**ADDENDUM 4**  
**Via E-Mail**  
**DATE: May 7, 2024**

**Contract: 23-C-00013; Morris Bridge Filter Building Improvements ReBid**

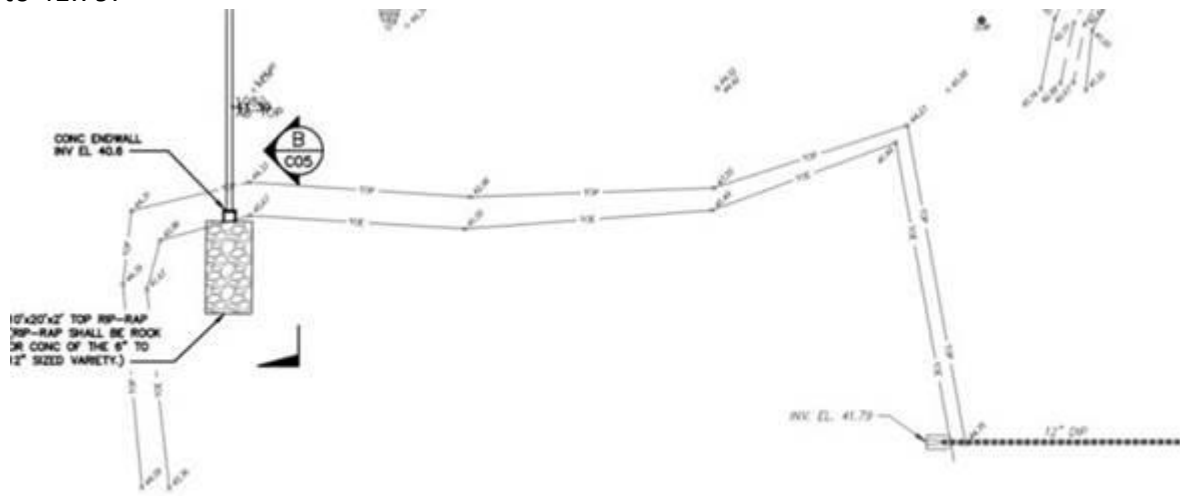
- f. Ultimate discharge location should be the onsite Stormwater Ponds 1, 2, or 3.
2. FL-A-302 note N06 state replacing wall panels above door. Picture taken at site visit does shown framing of existing condition (see attached).

- a. Keynote N06 on sheets FL-A-301 and FL-A-302 states 'Replace missing panel over galvanized furring to match existing with matching trim'.
  - b. There is a missing panel like the adjacent panels shown in the image below.
